HI-STAR PBT (TPBAR) Public Session

November 22, 2022

RSIs Affecting Impact Limiter

Impact Limiter Testing

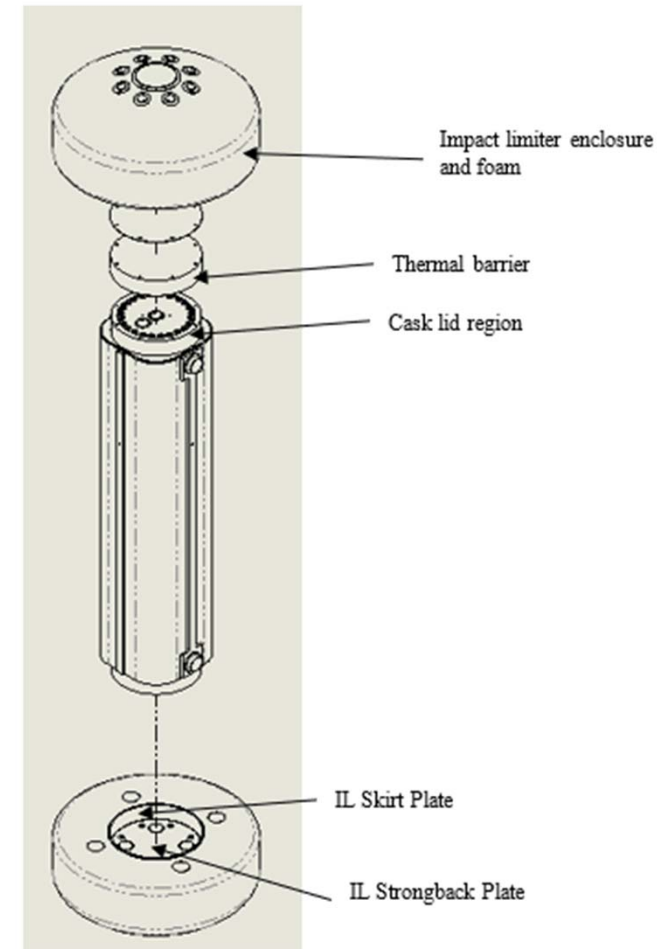
- 2-1 Provide expanded test data for the prototype impact limiter and expanded test data for the prototype foam material.

- 2-2 Provide expanded test data to justify the assumption that only localized damage to the impact limiter stainless steel skin seam welds will occur and that only minimal impact limiter foam material will be consumed by combustion.

- Static crush tests of 2.5" x 2.5" foam specimens (unconfined)
- 9-meter drop tests of 1/4-scale impact limiter conducted at Oakridge National Lab facility
 - ✓ End drop and slapdown drop orientations
 - ✓ Package instrumented with accelerometers
 - ✓ High speed digital photography

Fire Accident Condition Modeling

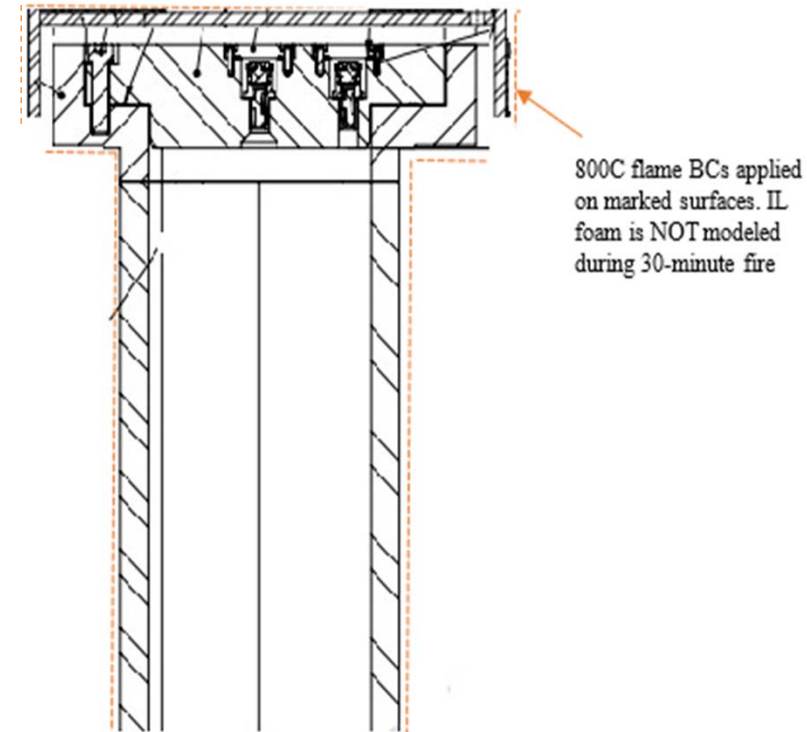
- 3-1 Provide justifications and additional explanations in Section 3.4.2 of the HI-STAR PBT safety analysis report (SAR) on how the four papers in Attachments A – D of the Holtec Report No. HI-2200641, Revision 0, provide an accurate representation of the material properties (e.g., thermal conductivity, density, specific heat) for the polyurethane foam, foam char, and air, as well as the quantity of foam char for the HI-STAR PBT impact limiter material during the regulatory fire and post-fire hypothetical accident conditions (HAC). Alternatively, provide HAC fire testing results of the HI-STAR PBT impact limiter with the foam that demonstrates the material assumptions in the HAC thermal model are accurate.

- Thermal analysis of the HAC is performed in three steps:
- Thermal Model A
 - Includes entire cask, the thermal barrier and the strongback/skirt plates sections of the impact limiter.
 - Computational domain enclosed by the dashed lines in the adjoining figure.
 - Foam is not modeled.
 - 800°C flame boundary conditions applied on the outer surfaces of the strongback/skirt plates and the exposed cask surfaces.
- ✓ This places the fire right next to the cask.
